Watts Bar Nuclear Plant, Unit 2  
NRC Docket No. 50-391

**Subject: WATTS BAR NUCLEAR PLANT (WBN) UNIT 2 – INSTRUMENTATION AND CONTROLS STAFF INFORMATION REQUESTS**

**Enclosure 1**  
**TVA Letter Dated December 22, 2011**  
**TVA Responses to Instrumentation and Controls Staff Information Requests**

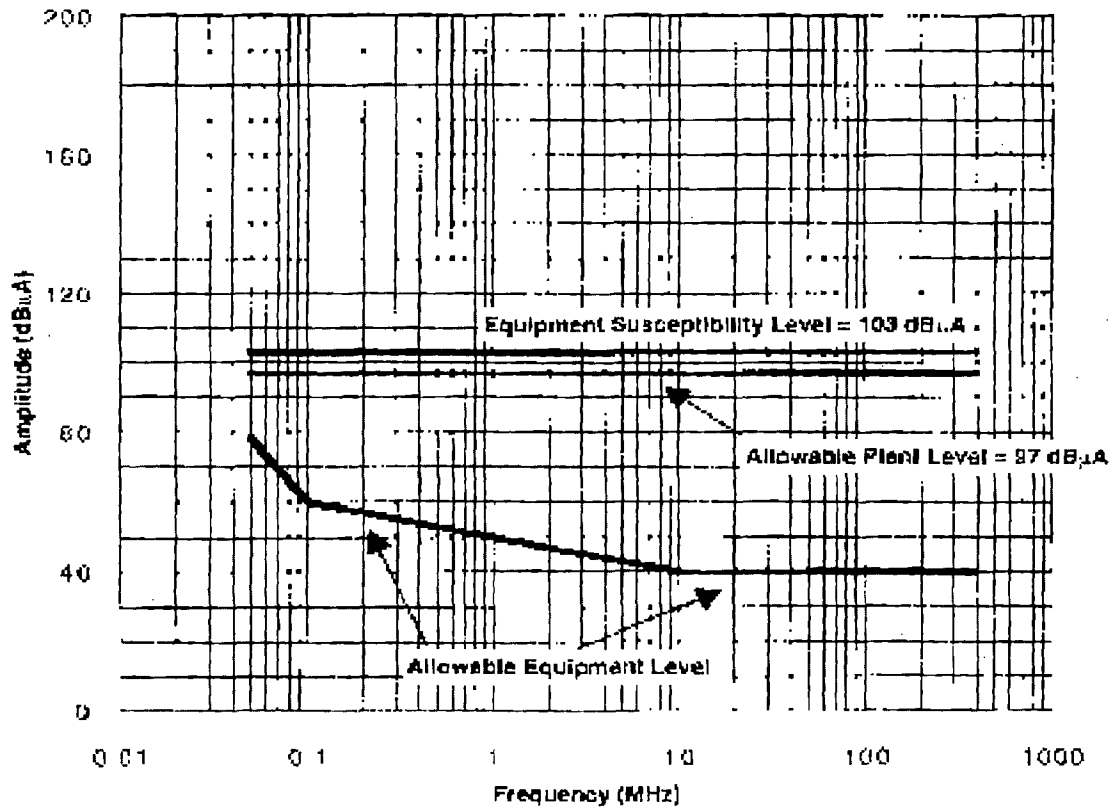
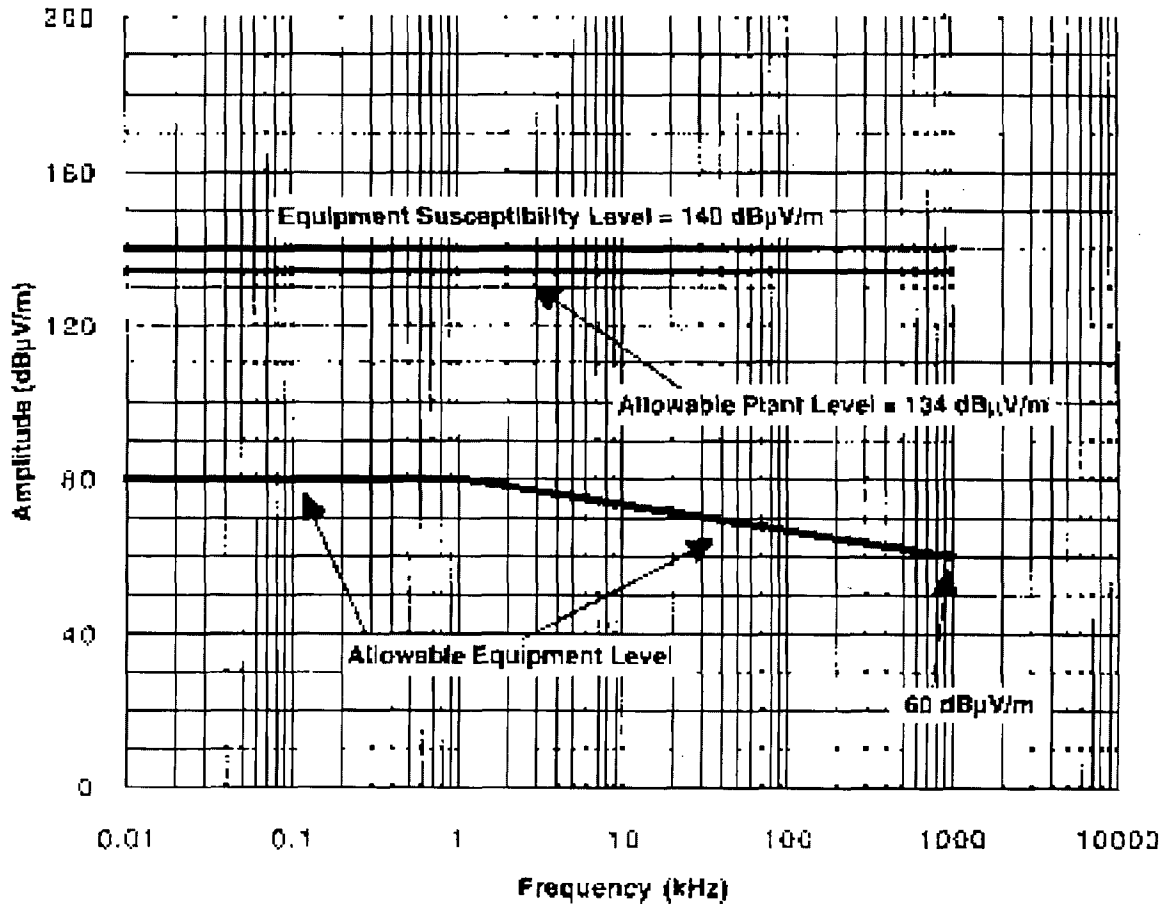
- b. *In response to staff request for an explanation for using an alternate method for high frequency radiated emissions tests, TVA in its September 30, 2011, letter under Item Number 15, stated that the alternate method EN 55022 is more restrictive than the Regulatory Guide 1.180 and Electric Power Research Institute (EPRI) suggested methods. This statement is not backed by specific examples of how the EN 55022 is more restrictive for the test levels and the frequency ranges. Therefore, TVA is requested to provide further explanation of how the test method is more restrictive over the test levels and frequencies.*

*In response to staff request for an explanation for using an alternate method for high frequency radiated emissions tests, TVA in its September 30, 2011, letter under Item Number 15, stated that the alternate method EN 55022 is more restrictive than the Regulatory Guide (RG) 1.180 and Electric Power Research Institute (EPRI) suggested methods. This statement is not backed by specific examples of how the EN 55022 is more restrictive for the test levels and the frequency ranges. Therefore, TVA is requested to provide further explanation of how the test method is more restrictive over the test levels and frequencies.*

The EPRI limits are reported in dB $\mu$ A while the CISPR standards reference the value in dB $\mu$ V referenced to a 50 ohm impedance. To convert either subtract 34dB from the CISPR requirements or add 34dB to the EPRI requirements. The following table provides a comparison of the CISPR and corrected EPRI limits.

The CISPR standards list the level at 10m while the EPRI (and MIL-STDs) use 1m. The field strength in the far field varies linearly with distance. So, either subtract 10dB from the EPRI standard values or add 10dB to the CISPR Standard values. The following table provides a comparison of the CISPR and corrected EPRI limits.
